FROM: *JLS*
Jennifer Steingasser, Deputy Director, Development Review & Historic Preservation

DATE: March 22, 2023

SUBJECT: Office of Planning Report for Large Tract Review Case No. 2022-01
2650 Woodley Road, N.W. and 2601 Calvert Street, N.W.

Figure 1 | Site Access and Circulation Plan

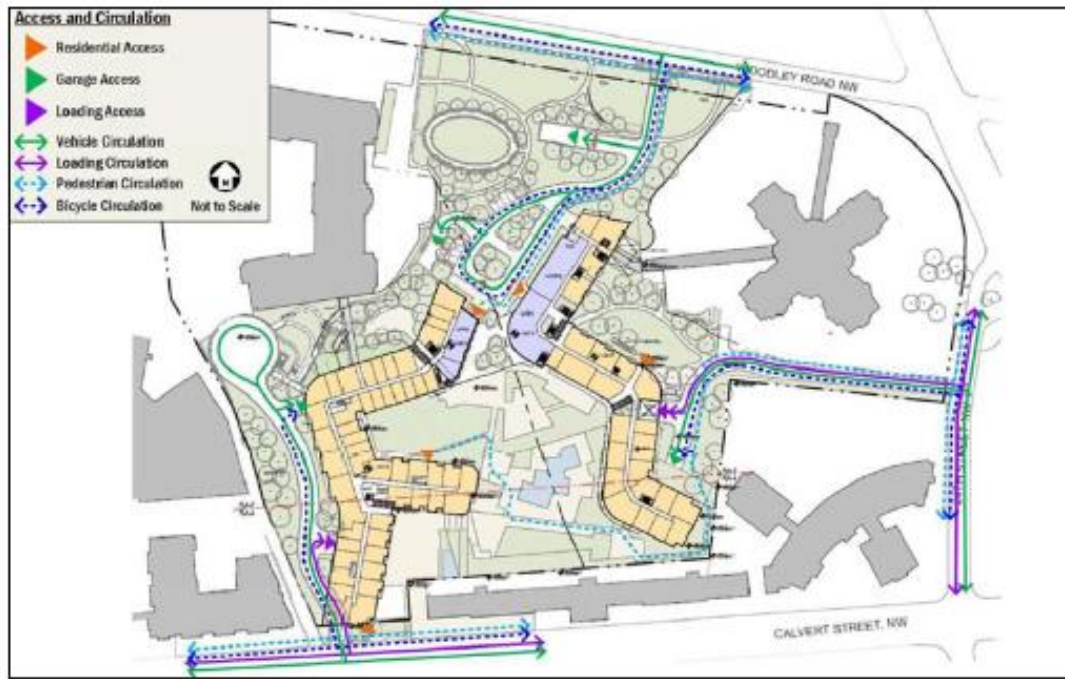
- Older site plans for previous proposals show that connectivity for both modes can occur on this site despite existing grades;
- The current site layout creates barriers for non-auto modes. This project has demonstrated elevation challenges precluding this connectivity;

- The site plan show steps leading down from the Woodley building, in the northwest corner of the site, to the new circular drive which connects to Calvert Street NW. The Applicant should evaluate the feasibility of adding a pedestrian connection along the drive aisle extending from the steps at the north end to Calvert Street NW and install a sidewalk with staircases to connect across the site; ;

- Revise the site plan to provide improved pedestrian access through the site including any needed staircases, specifically along the drive aisle which connects to Calvert Street NW and leads to an internal staircase at the edge of the circular drive. Ensure ADA accessible sidewalks are on all driveways connecting to public sidewalks. The proposal currently has no connections between Calvert Street and Woodley Road and require a pedestrian to walk around a mega-block to get to the other side. This is not acceptable for a transit-oriented development (TOD) site and until this is resolved, DDOT cannot support the proposed curb cuts and accompanying access to the roadway network;
